IN HOUSE REJECTION: KAIZEN

3a.5 Can not Assemble

Physical Phenomenon : **Spatters in tube**
Due to : Man / Machine / **Method** / Material

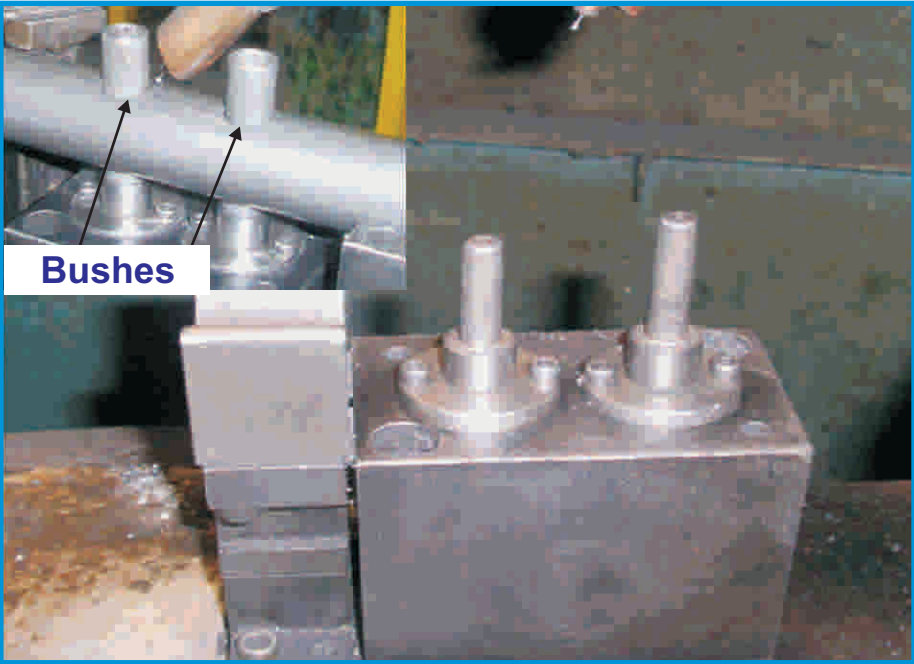
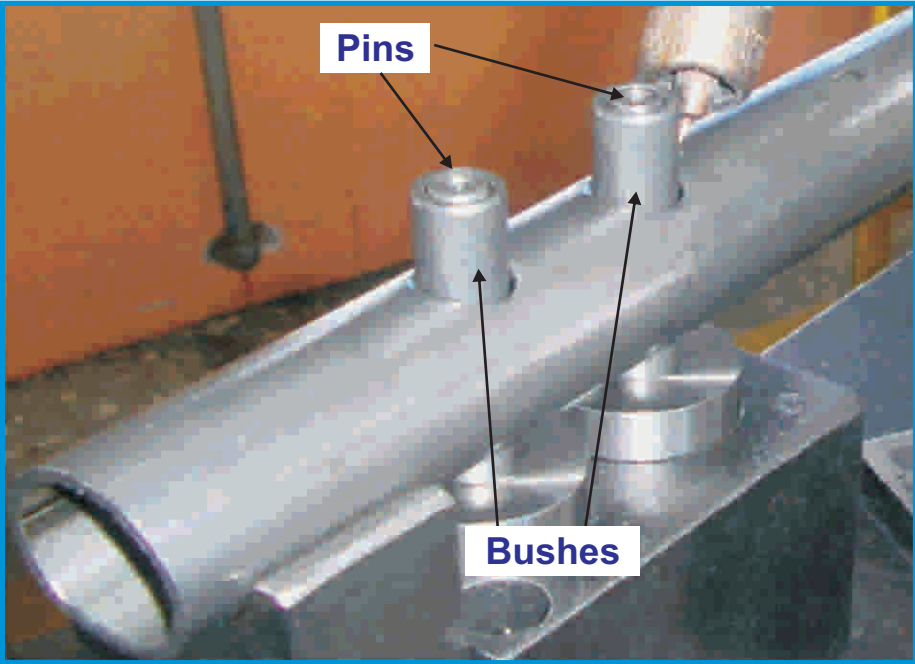
Spatters entry in bush.

Root Cause : No masking while bush welding.

Kaizen Idea : Masking to bush.

Kaizen : Provided pins having more height than bush height.
